Produktlinie Fahrerassistenzsysteme

Description of the Changes to the Sensor from ARS 2-A to ARS 2-C

June 6, 2003

Polarizing key of the connector

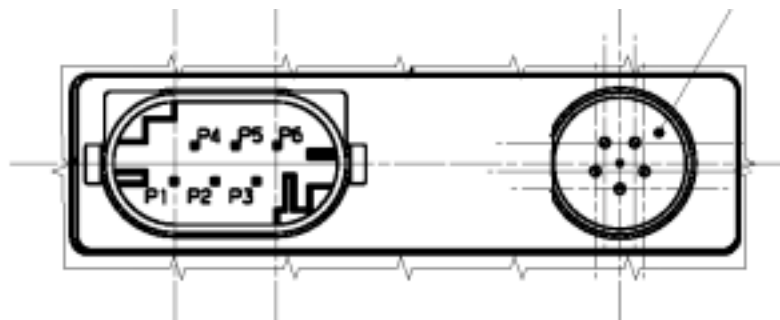
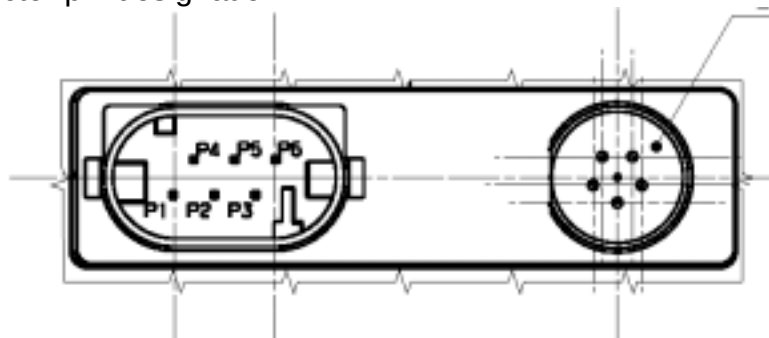
Polarizing key of the connector changed (see pictures below)

ARS 2-A and ARS 2-B connector pin designation

ARS 2-C connector pin designation:
